1984 Corvette: Recall: Front Brake Caliper Bracket Bolt

Subject: PRODUCT SAFETY FRONT BRAKE CALIPER BRACKET BOLT

Model and Year: 1984 CHEVROLET CORVETTE MODELS (VIN: E5100001 - E5109828)

Bulletin Number: 84-C-02 - (06/01/1983)

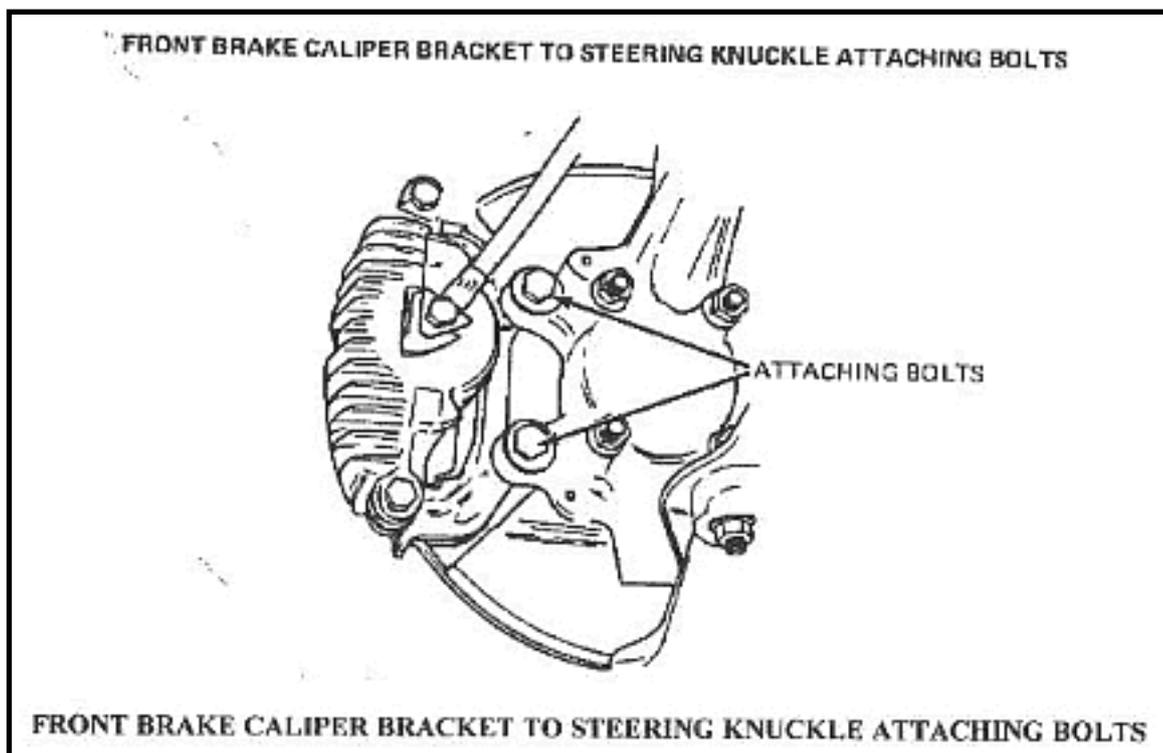
GENERAL MOTORS HAS DETERMINED THAT A DEFECT WHICH RELATES TO MOTOR VEHICLE SAFETY EXISTS IN CERTAIN EARLY PRODUCTION 1984 CORVETTES. THE FRONT BRAKE CALIPER BRACKET TO STEERING KNUCKLE ATTACHING BOLTS MAY LOOSEN AND FALL OUT. THE FRONT BRAKE CALIPER MAY THEN BECOME PARTIALLY DETACHED FROM THE KNUCKLE ASSEMBLY AND MAY CAUSE THE WHEEL TO LOCK. SHOULD THIS OCCUR WHILE THE VEHICLE IS IN MOTION, IT COULD RESULT IN A LOSS OF CONTROL, A VEHICLE CRASH COULD OCCUR WITHOUT PRIOR WARNING.

TO PREVENT THE POSSIBILITY OF THIS CONDITION OCCURRING, CHEVROLET DEALERS ARE TO REPLACE THE FRONT BRAKE CALIPER BRACKET TO STEERING KNUCKLE ATTACHING BOLTS ON ALL INVOLVED VEHICLES IN ACCORDANCE WITH THE SERVICE PROCEDURE AS OUTLINED IN THIS CAMPAIGN BULLETIN.

IMPORTANT: THE NEW BOLT P/N 140799998 CAN BE IDENTIFIED BY THE ORANGE COLORED ADHESIVE PATCH MATERIAL ON THE BOLT THREADS.

1. RAISE HOOD.
2. REMOVE THE UPPER CALIPER ATTACHING BOLT.
3. USING THE NEW 3/8 IN. CYLINDRICAL WIRE BRUSH PROVIDED, FIRST THOROUGHLY CLEAN THE BRUSH WITH 1,1,1 TRICHLORETHANE SOLVENT; LET DRY.
4. CLEAN THREADS IN THE UPPER CALIPER ATTACHMENT BY THREADING THE BRUSH THROUGH THE THREADS AS FAR AS POSSIBLE, THEN REMOVE BY REVERSE THREADING. THIS STEP MUST BE PERFORMED TO REMOVE RESIDUAL TEFLON NO MATTER HOW CLEAN THE THREADS APPEAR.
5. BLOW OUT THREADS WITH AIR GUN.
6. INSTALL NEW BOLT PROVIDED, P/N 140799998, AND TORQUE TO 97 N.M (70 FTL.LB.).
7. REPEAT THE PROCESS FOR THE LOWER CALIPER ATTACHING BOLT.

8. RECHECK TORQUE ON BOTH BOLTS IMMEDIATELY.
